Engineers Comments Regarding Surface Water Drainage

Application Reference:	LU/141/26/DOC	Reviewer Reference:	ADC/EXT2/D2134/111
Planning Officer:	Hannah Kersley	Date of Review:	01.09.2026
Site Name:	Southern Allotments Hampton Park Littlehampton		
Application Description:	Approval of details reserved by condition imposed under LU/47/11 relating to condition 10-surface water drainage.		
Assessment Number:	2

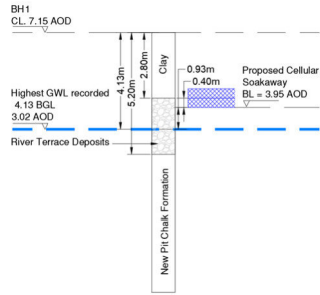
year, and 100-year storm events.				
4.			The Soils geotechnical report has now been provided which verifies groundwater monitoring and soil types. The designer has advised the groundwater datum of 3.02m AOD for design to enable the compliant 1.0m freeboard to be verified. It is not clear how this figure has been determined. The design states the base of the soakaway must penetrate a minimum 400mm into the River Terrace Deposit stratum, which may conflict resulting in a 1.0m freeboard non-compliance. Please provide an explanation and/or updated design if necessary. Designer Response 20/07/2026:	Noted. The marginal breach of the 1.0m freeboard is accepted as a very minor relaxation as summarised by the designer. Comment closed.

The highest groundwater level recorded at BH1 was 4.13m below ground level. Based on the conservatively interpolated cover level at BH1 of 7.15m AOD, this corresponds to a peak groundwater level of 3.02m AOD. Please refer to the supplementary sketch below. The soakaway formation level has been lowered by 100mm to achieve a minimum 400mm penetration into the River Terrace Deposits, encountered at approx. 4.35m AOD. This penetration is necessary to provide adequate hydraulic contact with the permeable stratum and achieve compliance with the required half-drain time. A higher formation level would reduce the penetration into the River Terrace Deposits and would not satisfy the hydraulic performance requirements.		
--	--	--	--	--	--

The resulting separation between the soakaway formation level and the highest recorded groundwater level is 930mm. Whilst this is 70mm below the recommended minimum 1.0m separation, the shortfall is considered marginal. The adopted groundwater level is based on the highest recorded monitoring result and therefore represents a conservative design scenario. All other recorded groundwater levels provide in excess of the recommended 1.0m separation. The proposed formation level therefore provides the maximum practicable separation above groundwater while maintaining the minimum penetration into the River Terrace Deposits required for effective infiltration. Given the minor nature of the shortfall and the conservative use of the highest recorded		
--	--	--	--	--	--

groundwater level, the residual risk of groundwater interaction is considered to be low. 		
--	--	--	---	--	--
